RE: Starbucks and T-Mobile Lot 3B and 4A Krania Subdivision Grading and Drainage Plan Engineer's Stamp Date 3-9-2017 (File: K09D031C)

RE: Revised Grading Plan (K09-D031C) Starbucks and t-mobile Albuquerque, New Mexico

The purpose of this letter is to accompany the enclosed revised grading plan for the development. The grading plan for this site has been revised to address your written comments dated 3/6/17. The following is a summary of your comment and the narrative as to how we addressed

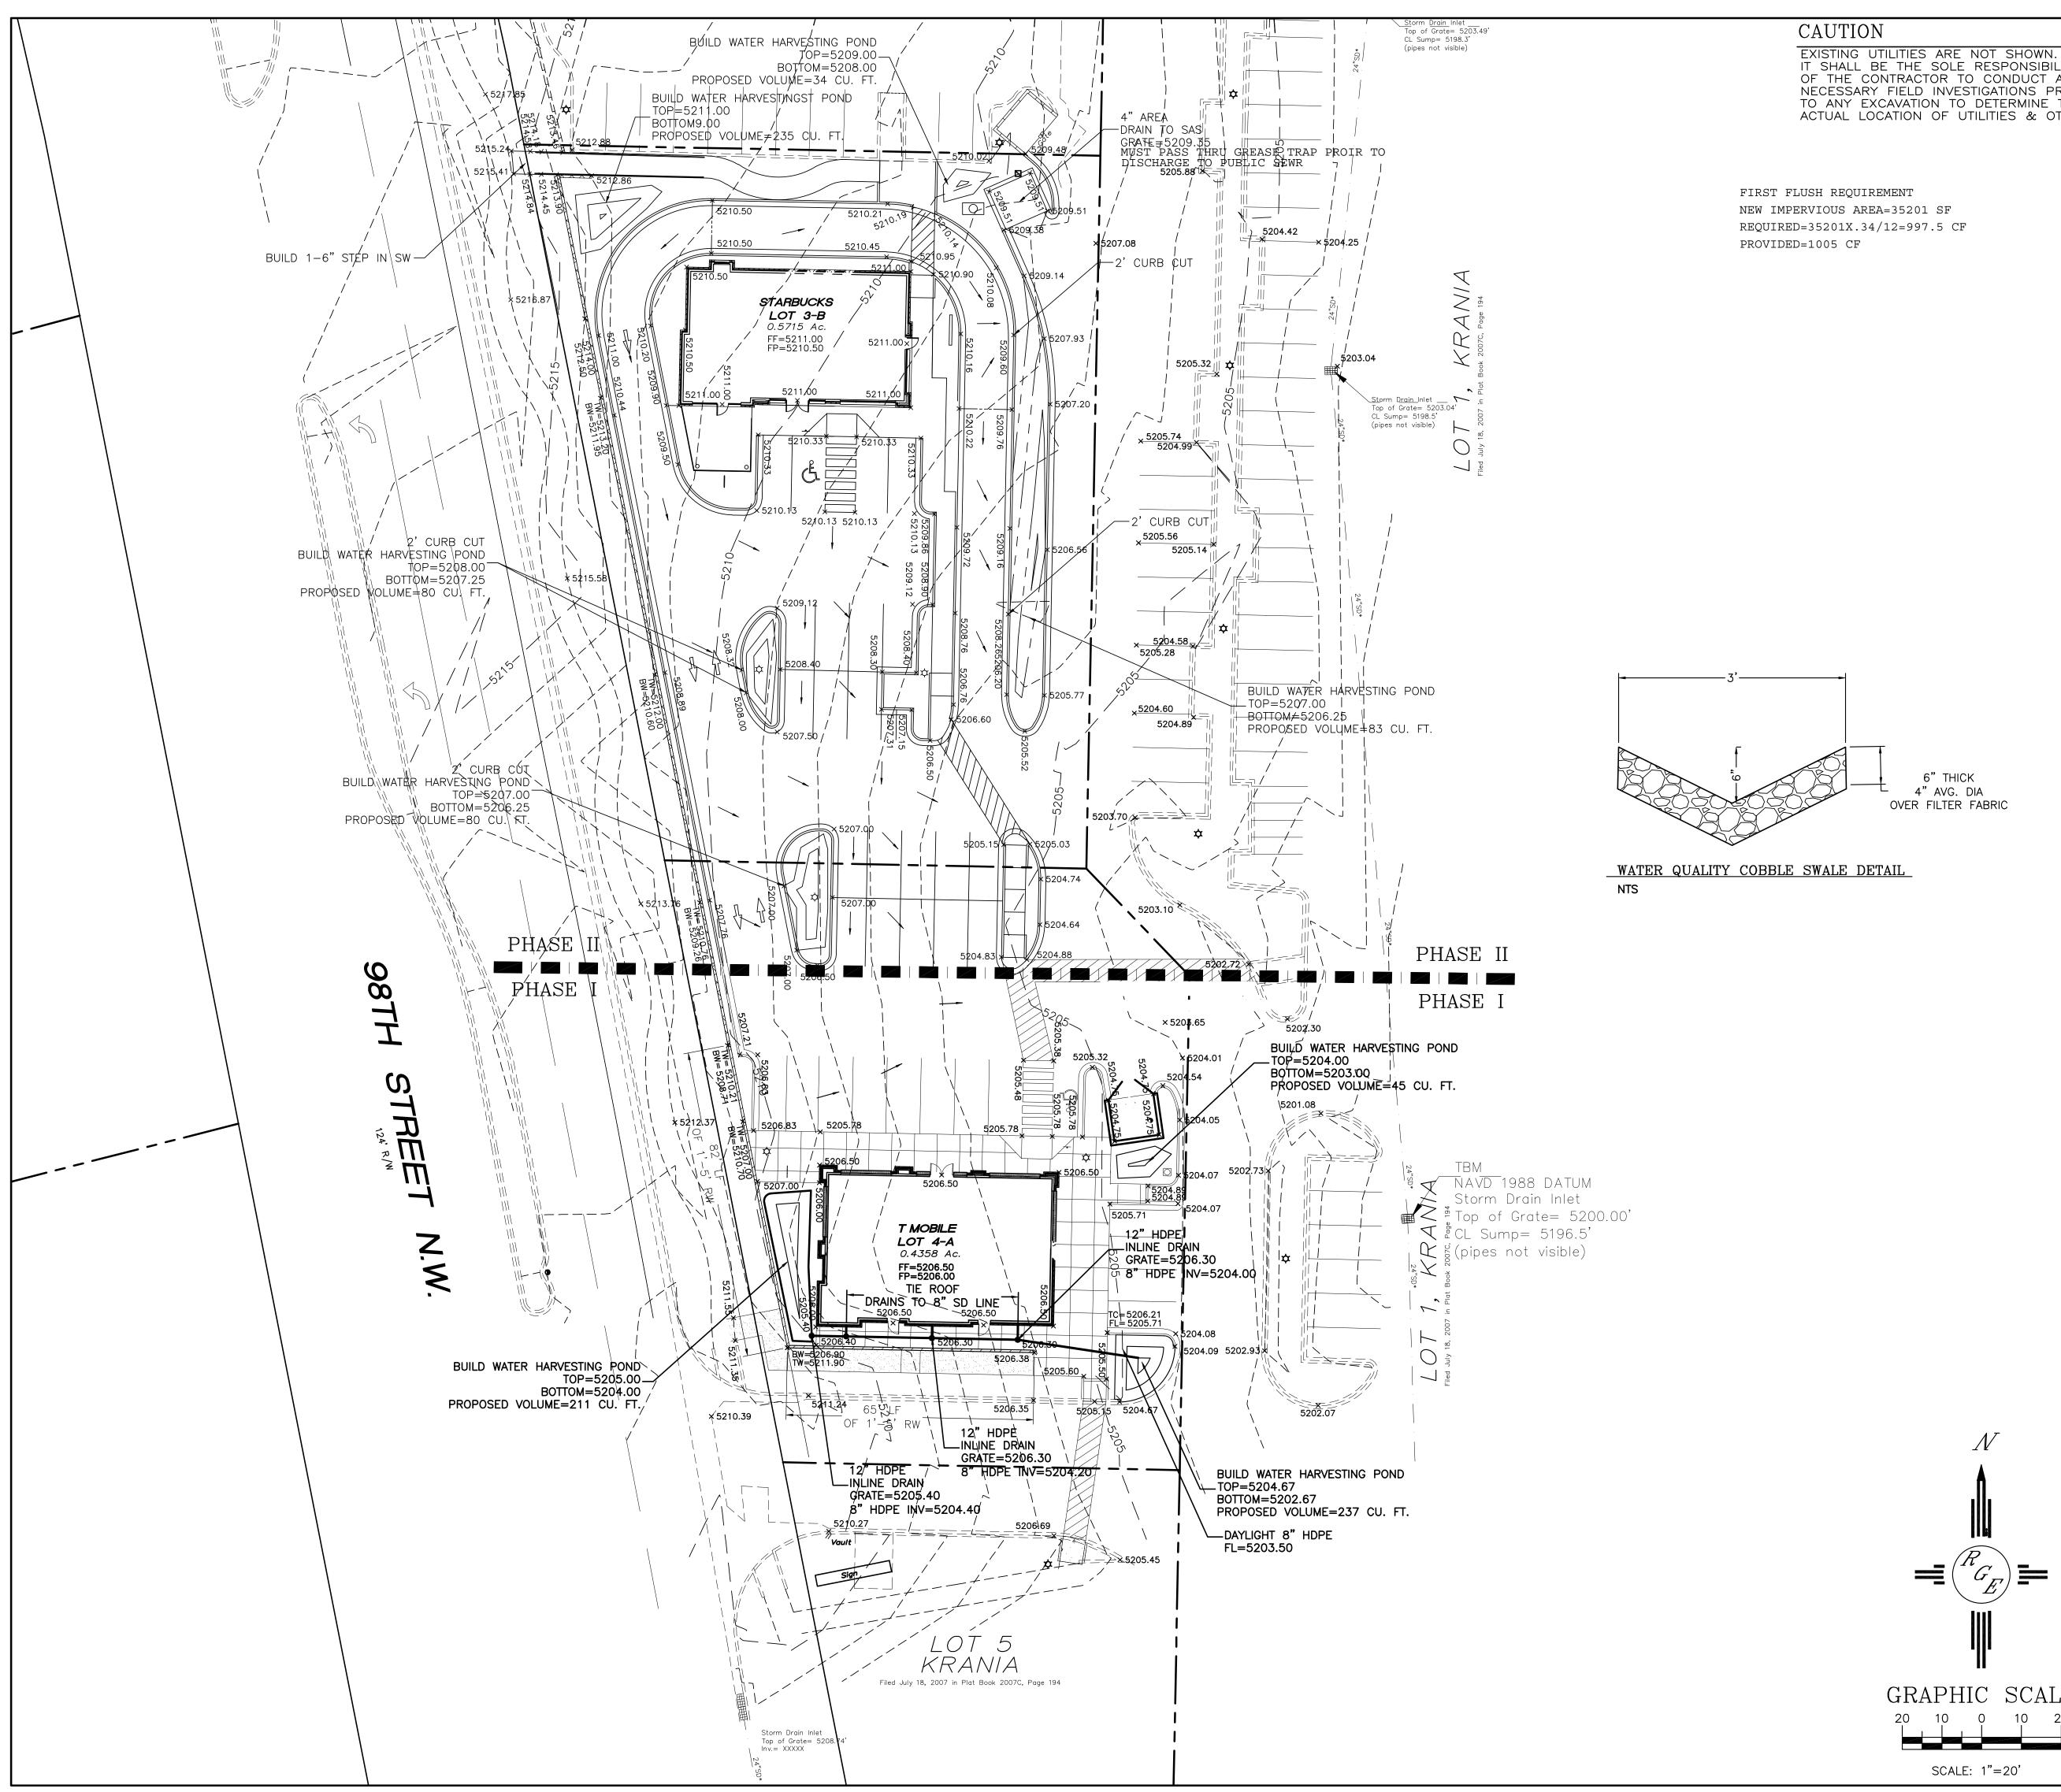
1. Drain must go to grease trap

- T-mobile trash enclosure does not need drain
 We have removed the drain.
- 3. Provide Cross access and drainage easement.

4. Provide documentation on free discharge.

We have added this note.

We placed a red box around the verbiage on the plat dedicating the drainage easement. The placement of the note adjacent to dimension leaders for the sewer easement are confusing, but the lots have cross lot drainage, access and parking as shown on plat.

This is a pad site of the Krania subdivision. The developed condition assumptions are located in File K09/D031. As shown within the drainage report by Ron Bohannan 10/18/06 this site is located in basin 5. The site is allowed to free discharge based upon 75% D and 25% B. The site impervious exceeds the 75% yet the depressed landscaped areas and first flush ponds are treated at type A since they don't discharge and the peak discharge is less than allowed
